**PLANNING APPLICATION NO.:** PLN200186  
**DEPARTMENT REFERENCE NO:** PPR 34425/20  
**PROPERTY ADDRESS:** 40-50 ROKEBY STREET, COLLINGWOOD VIC 3066

TO: John Theodosakis (Statutory Planning)  
FROM: Amruta Pandhe (Urban Design)  
DATE: 04 June 2020  
SUBJECT: 40-72 Rokeby Street, Collingwood  
APPLICATION NO: PLN20/0168  
DESCRIPTION: Development of a fifteen storey building and use of the land for shop, food and drink premises and office, including a reduction in the associated car parking requirement.

Urban Design comments have been sought on public realm matters. The comments are based on Architectural Plans dated 1st November 2019.

Ground Floor Plan (section near the main pedestrian entrance)

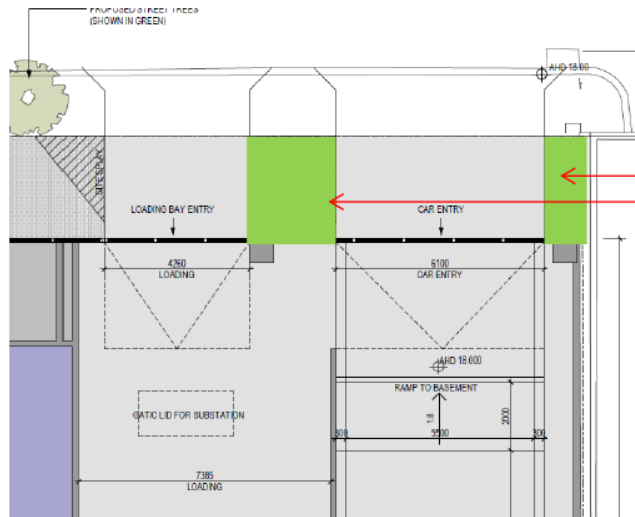
bike spaces (outside E.O.T lobby). This will contribute in decluttering the space and provides an opportunity to have landscaping and seating within this space.

Potential location of planter boxes with integrated seating

Ground Floor Plan (section near vehicular entrances)

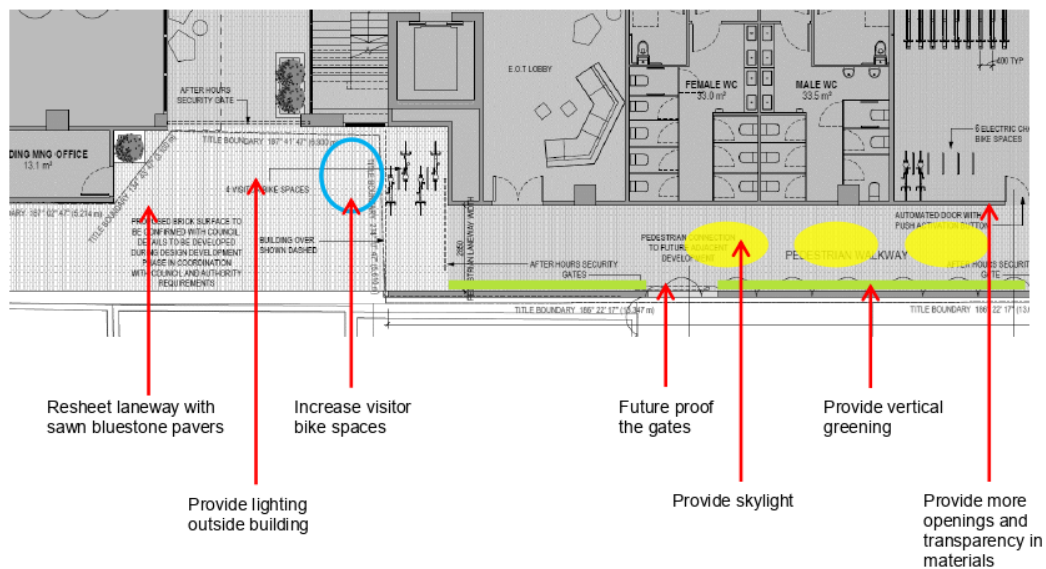
There are other landscaping opportunities (including vertical greenery), like the space between the car park entry and loading bay entry. Provision of landscaping in this space will also help in creating a clear separation between the two entries. The section on north of car park entry also provides landscaping opportunity. It is important to ensure that any landscape treatment and structures do not obstruct any sight lines of drivers.

Potential greening opportunities

The drawings need to provide more information and/or clarification about:

- There is insufficient detail about the 9.5m long security gate shown across the pedestrian walkway. Further material and design details for the gates should be provided, including their level of transparency as this will impact the pedestrian environment during weekends and evenings.
- Provide additional spot levels on the plan to clarify the height differences between the footpath and paving. We would expect a seamless transition between the footpath and paving, with any height differences resolved through grading of the paving to ensure no steps will be required.
- Show location of all existing infrastructure on footpath like electricity pole, parking signs, street name sign. If any of this infrastructure is proposed to be relocated show the proposed new locations.

Ground Floor Plan (section near rear laneways)

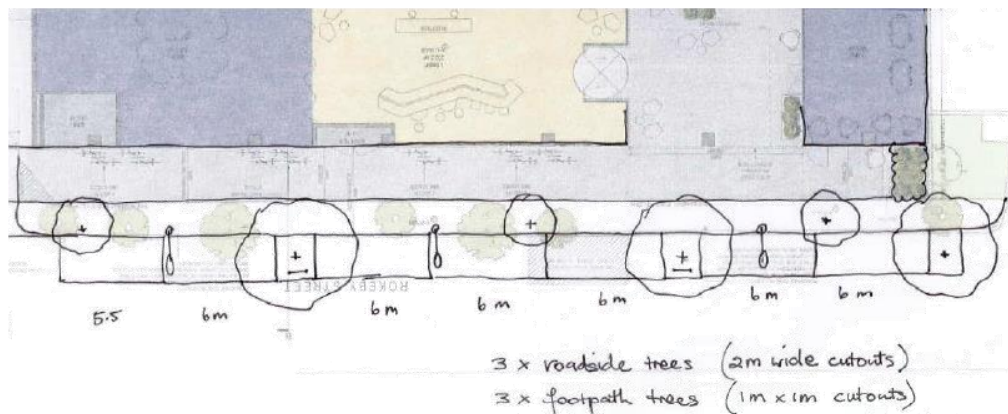
- Explore providing some active frontages along the walkway.
- The wall along bike storage, EOT lobby and comms room can provide more transparency through use of materials and openings.

- The wall along the eastern boundary can incorporate vertical greenery.
- Confirm whether the walkway is covered or open to sky. If it is covered it is recommended to provide natural skylight openings to allow natural light into the walkway. Confirm that artificial lighting will be provided within the walkway.

- Ensure future proofing the gates that provide pedestrian connection to future adjacent development. This can be achieved by providing openings in the wall and using material that can easily be replaced with gates when the adjacent development is built.

The drawings need to provide more information and/or clarification about:

- Confirm delineation between public and private land. There needs to be a clear distinction between public and private realm along Rokeby Street and laneways.
- Confirm Paving / Surface material within the 3m setback space including the vehicular crossovers and all pedestrian walkways.
- Council engineer should be consulted in regard to storm water management and grading along Rokeby Street and laneways. This to ensure that the overland flow at big rain events will not cause any flooding issues.

**CLEARANCES TO PARKING SPACES – BASEMENT 2**

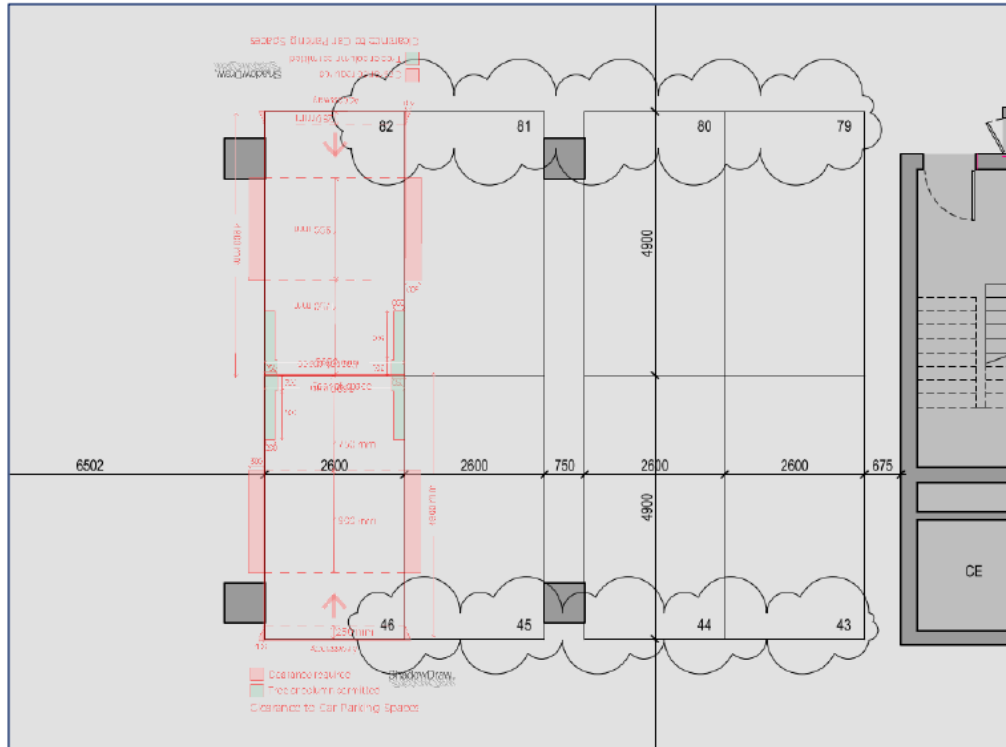
Columns adjacent to spaces 81, 82, 45 and 46 are positioned outside of the parking space clearance envelopes as per *Diagram 1 Clearance to car parking spaces* in Clause 52.06-9.

**Vehicle Crossing – Cross Section**

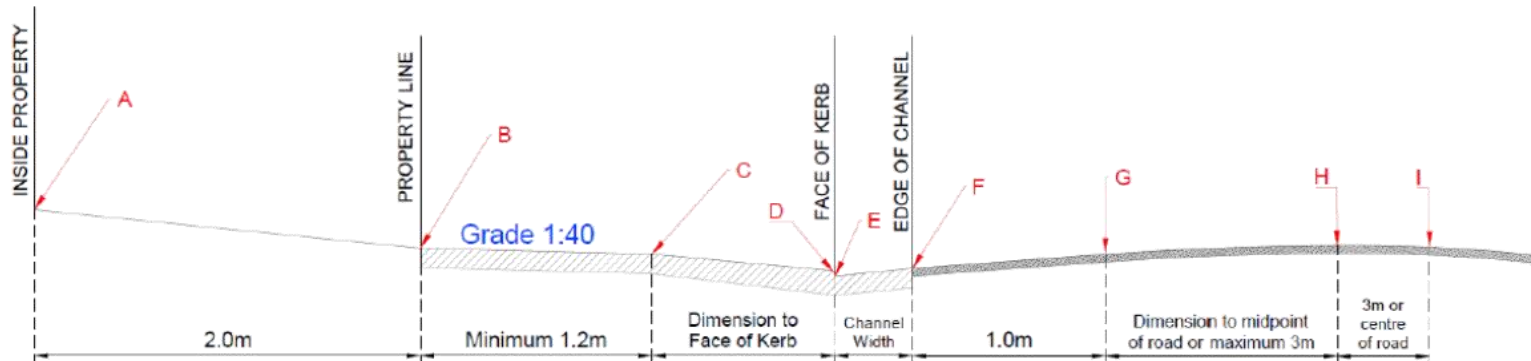
The designer is to submit a 1:20 scale cross section for each proposed vehicle crossing showing the following items:

- o Please note the cross section must be fully dimensioned. As shown in the sketch below.
- o Please show both the existing and proposed surface.
- o The maximum allowable cross-fall between points B and C is 1:40 (2.5%).
- o A bullnose (max 60mm) is permitted at point D, however not compulsory.
- o The levels shown must be exact reduced levels, to three decimal points. Interpolation of levels is not acceptable.
- o The designer must demonstrate that an 85<sup>th</sup> or 99<sup>th</sup> percentile vehicle profile can traverse the design cross section as per the Australian/New Zealand Standard ground clearance template (AS/NZS 2890.1:2004).
- o Significant level changes to the existing footpath level B to C will require additional level design either side of the proposed crossing.
- o Please include any additional levels or changes in grade that are not shown in the diagram.

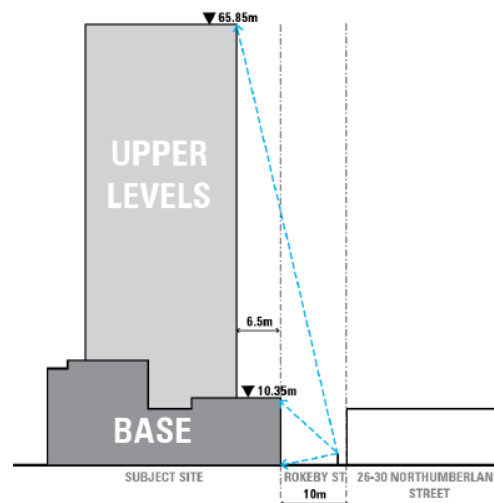
- With this in mind, we are not convinced that the proposed development at a height of 15 storeys will sit comfortably within the emerging 'height datum' of the area. While the site is not a designated strategic development site and does not benefit from corner of a main road to demarcate a junction, we recognise that the site has a substantial land area which could potentially absorb and sensitively conceal an increase in development scale – as is invited in Clause 22.10 (Design and Built Form).

- The assessment of taller development in this part of Collingwood will need to be assessed against a series of urban design tests to determine an acceptable maximum height. Clause 22.10 suggest the use of massing or articulation, or changes of surface treatment, or a combination of these to relate taller buildings to the scale of their surrounds and to diminish visual bulk, and any off-site amenity impacts. More specific guidance is provided in DDO11, which states that development over 4 storeys should demonstrate a high standard of architectural design and minimise overshadowing of adjoining streets, public spaces or private properties.

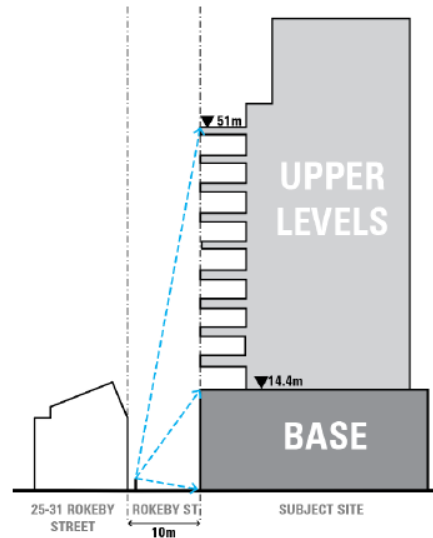
- DDO11 does not seek to visually conceal upper levels behind the street walls. However, the cumulative impact of a narrow street profile and a 15-storey tower development that proportionally and visually dominate the street wall is not considered a positive pedestrian environment along Rokeby Street. This effect will be further exacerbated when replicated on adjoining sites, or across the road. A more appropriate urban design response along these narrow streets will be to establish a building height to street width ratio of 2 to 1.

- We are generally supportive of the proposed party-wall arrangements to the side boundaries (north and south) at the lower levels. In this infill context, side elevations are likely be concealed by subsequent future redevelopment of neighbouring sites.

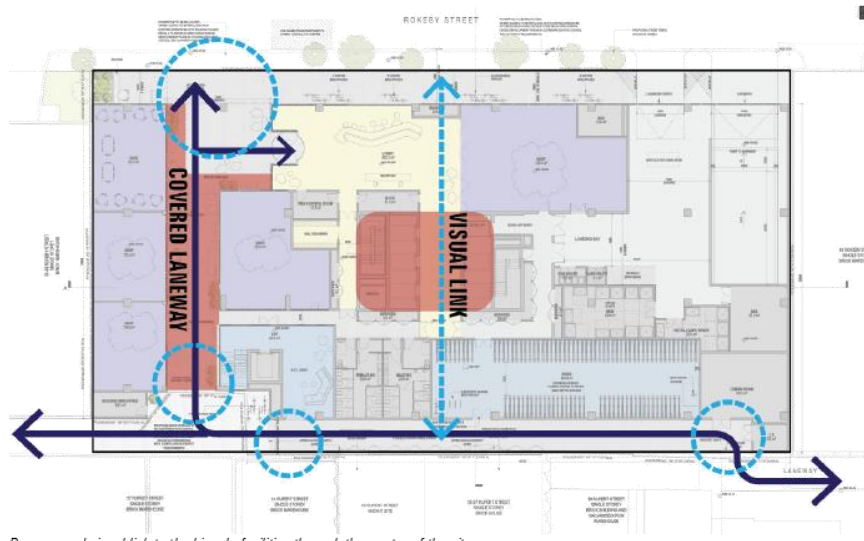
- The proposed site planning is underpinned by a centrally positioned circulation core and the creation of two new laneways (Urban Context Report Page Chapter 6). It comprises a new east – west lane (between 4.8m and 9.5m wide) connecting to Byron Street further west and ground level setback (2.9m) from the eastern boundary to connect existing north and south laneways. Access to the commercial lobby and some ground level shops are through the new east- west laneway. Both laneways as we understood it are not accessible to the public after hours (between 9pm to 6am).

- We agree with observations made in the Urban Context Report that the laneway network is a quintessential ingredient of the Gipps Street Precinct and indeed will bring about community benefits in the long term from pedestrian permeability perspective and maximising ground level vibrancy, consistent with CI21.05 of the Yarra Planning Scheme.

- Visibility to the commercial lobby (centrally positioned) and bike storage should be available on approach from Rokeby Street and the rear laneway for site orientation and to enhance the image of the proposal as one that is promoting active transport and relocating the booster cupboard elsewhere. All of which seeks to enhance pedestrian and cyclists experience within the new semi- public spaces in accordance with C115.01 (Objective 2) and C122.07 of the Yarra Planning Scheme and CPTED- Principle 1- Natural Surveillance.

*Ground Floor Plan (section near the main pedestrian entrance)*

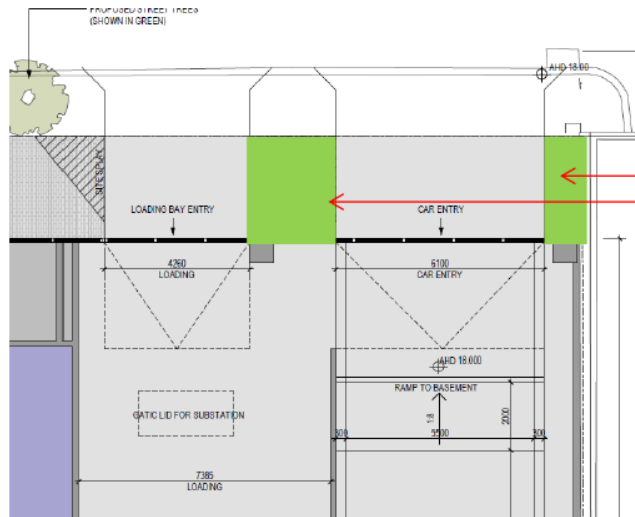
bike spaces (outside E.O.T lobby). This will contribute in decluttering the space and provides an opportunity to have landscaping and seating within this space.

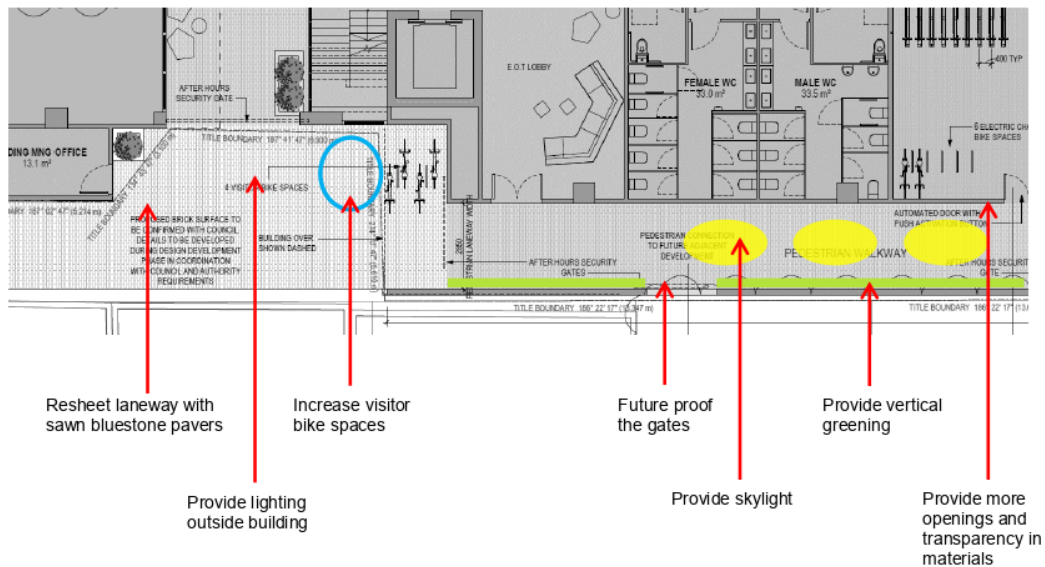
- Show general Grading and Drainage information (including within the laneway) to ensure the site layout is universally accessible, appropriate and well-designed.
  - RLs at all building entries and street interfaces.
  - Falls of pavements, including extents of significant falls (i.e. steeper than 1:33 and 1:20).
  - Drainage pits (and associated RLs).
  - Show drainage infrastructure, such as trench grates on plans.

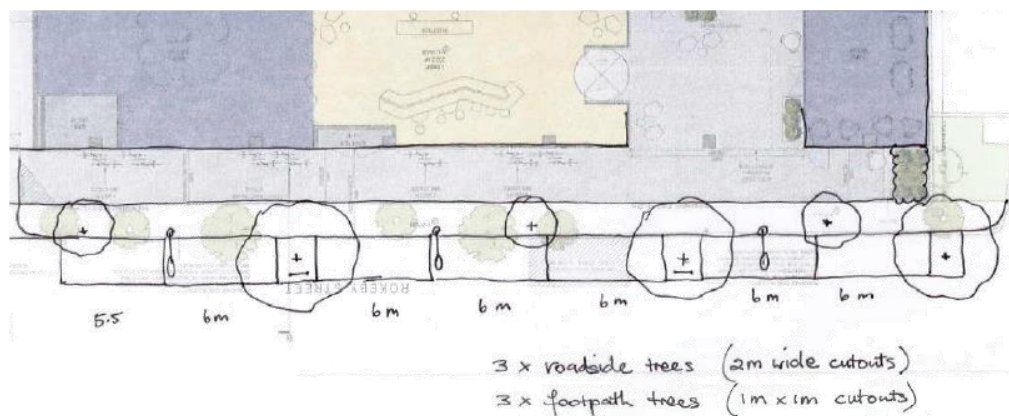
- Confirm delineation between public and private land. There needs to be a clear distinction between public and private realm along Rokeby Street and laneways.
- Confirm Paving / Surface material within the 3m setback space including the vehicular crossovers and all pedestrian walkways.
- Council engineer should be consulted in regard to storm water management and grading along Rokeby Street and laneways. This to ensure that the overland flow at big rain events will not cause any flooding issues.

**Massing and Setbacks**

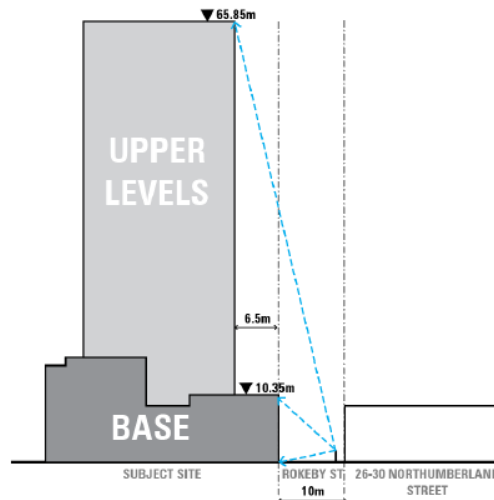
- DDO11 seeks to ensure that there is 'a consistent streetscape with active street-frontages and well-articulated buildings with street facades built to a height of up to 3-4 storeys'. Clause 22.10-3.3 further reiterates that new development to conform to existing development scale of adjoining sites. Our review of the existing streetscape identifies a street wall height of 2-3 storeys, with the exception of a more recent development up to 4 storeys at 26-30 Rokeby Street. What can be gleaned from these policy and physical contexts is a 2-4 storey streetwall response that would be appropriate to the narrower street profile and represents a better fit within its existing and emerging streetscape. We support the proposed 4 storey streetwall with a transition to the 2 storeys to the north, particularly to mitigate the short-term effect of new development within a renewal precinct of this kind.

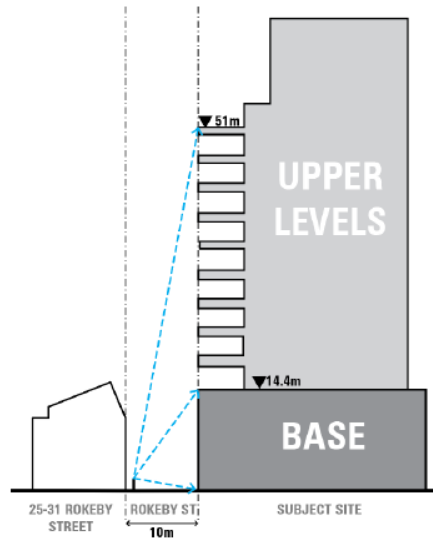
- DDO11 does not seek to visually conceal upper levels behind the street walls. However, the cumulative impact of a narrow street profile and a 15-storey tower development that proportionally and visually dominate the street wall is not considered a positive pedestrian environment along Rokeby Street. This effect will be further exacerbated when replicated on adjoining sites, or across the road. A more appropriate urban design response along these narrow streets will be to establish a building height to street width ratio of 2 to 1.

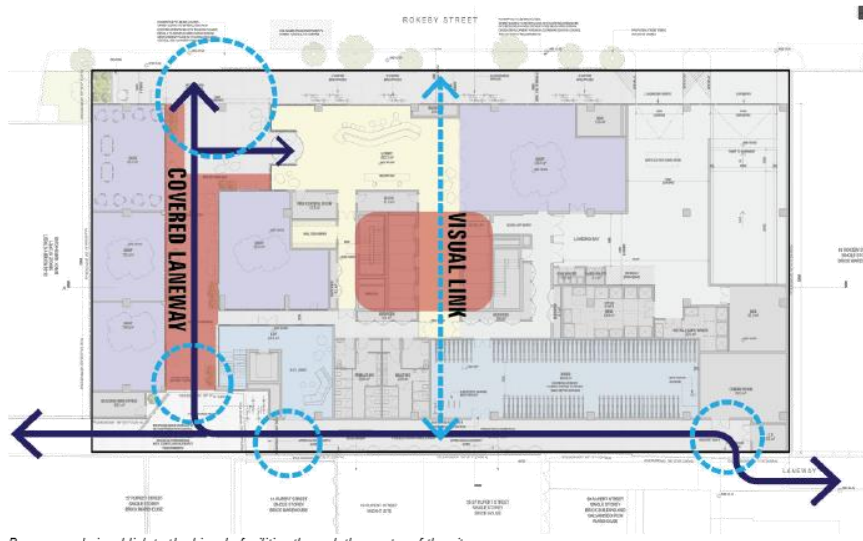
- The proposed site planning is underpinned by a centrally positioned circulation core and the creation of two new laneways (Urban Context Report Page Chapter 6). It comprises a new east – west lane (between 4.8m and 9.5m wide) connecting to Byron Street further west and ground level setback (2.9m) from the eastern boundary to connect existing north and south laneways. Access to the commercial lobby and some ground level shops are through the new east- west laneway. Both laneways as we understood it are not accessible to the public after hours (between 9pm to 6am).

- We agree with observations made in the Urban Context Report that the laneway network is a quintessential ingredient of the Gipps Street Precinct and indeed will bring about community benefits in the long term from pedestrian permeability perspective and maximising ground level vibrancy, consistent with CI21.05 of the Yarra Planning Scheme.

- Visibility to the commercial lobby (centrally positioned) and bike storage should be available on approach from Rokeby Street and the rear laneway for site orientation and to enhance the image of the proposal as one that is promoting active transport and relocating the booster cupboard elsewhere. All of which seeks to enhance pedestrian and cyclists experience within the new semi- public spaces in accordance with C115.01 (Objective 2) and C122.07 of the Yarra Planning Scheme and CPTED- Principle 1- Natural Surveillance.
